Subject: Docket No. 50-166, License No. R-70, University of Maryland.
Submittal of request for license amendment authorizing changes to technical specifications for the use of 16 additional TRIGA fuel elements in the Maryland University Training Reactor

The Maryland University Training Reactor (MUTR) hereby requests an amendment to the Facility Operating License No. R-70 for the addition of 16 lightly used TRIGA fuel elements into the current 93 element core. Attached is a Safety Analysis report formatted in accordance with NUREG 1537, chapter 16.1-Prior Use of Reactor Components. The technical analysis for this report was provided by Oregon State University Radiation Center.

Figure 1: Proposed location of additional elements.

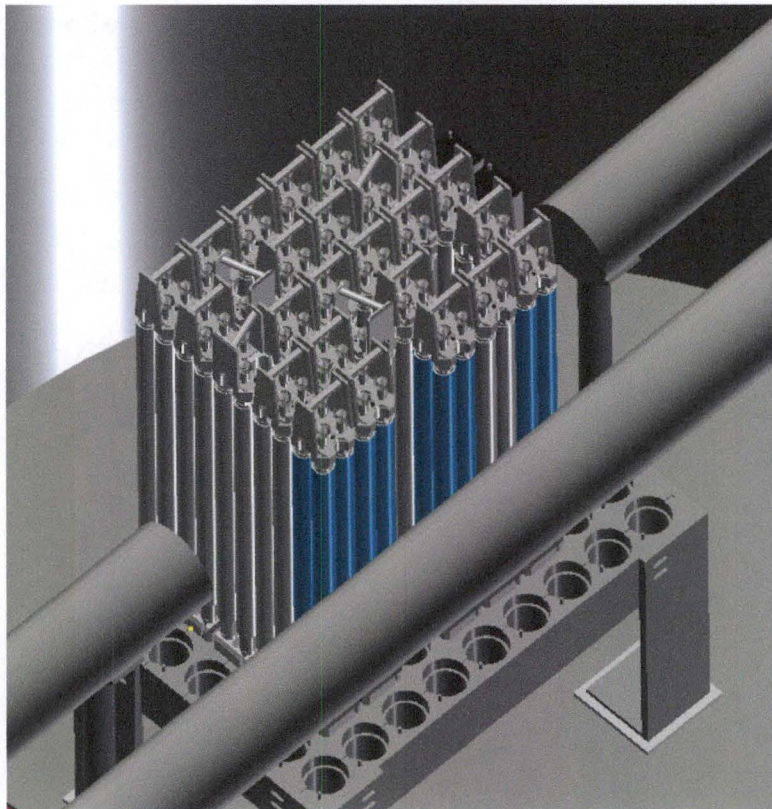
To optimize reactor efficiency while maintaining safety margins, 16 elements will be added to the core, increasing the inventory to 109 elements. The new bundles will be added to grid plate positions nearest the through-tube, indicated in blue in Figure 1.
